# **Assessment of projected sea level rise scenarios for the New Jersey Coast**

25 February 2021

New Jersey Business & Industry Association

This report (hereafter, the 'CFAN Review') evaluates the projections of sea level rise for the New Jersey coast provided in the 2019 Report entitled "New Jersey's Rising Seas and Changing Coastal Storms," led by a team of scientists from Rutgers University (hereafter referred to as the 'Rutgers Report').

**Figure 4.2:** Historic and projected relative sea level in centimeters (y axis) over time (x axis) for the period 1980 to 2050 in Atlantic City. Historic data is based on data utilized in figure 4.1 from NOAA tidal records. Future data is based on values found in the Rutgers Report Table 6.

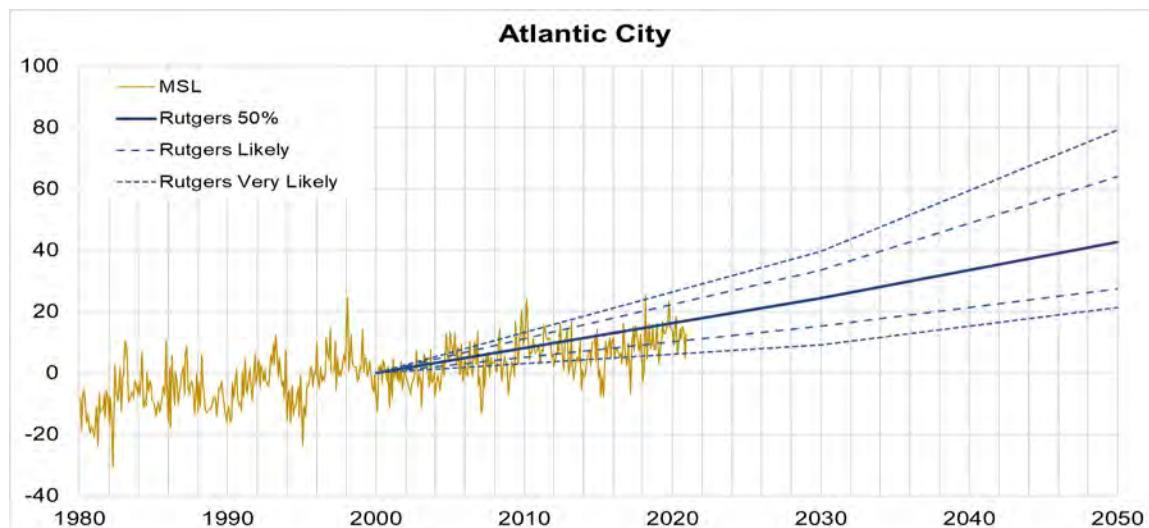
Figure 4.2 overlays the observed time series since 1980 of sea level on top of the Rutgers sea level rise projections for Atlantic City. The projections for 2030 and 2050 are independent of emissions scenario. The solid blue line is the Rutgers ~50%; the dash line reflects the *likely* bounds (17-83%) and the dotted line reflects the *very likely* bounds (5-95%).
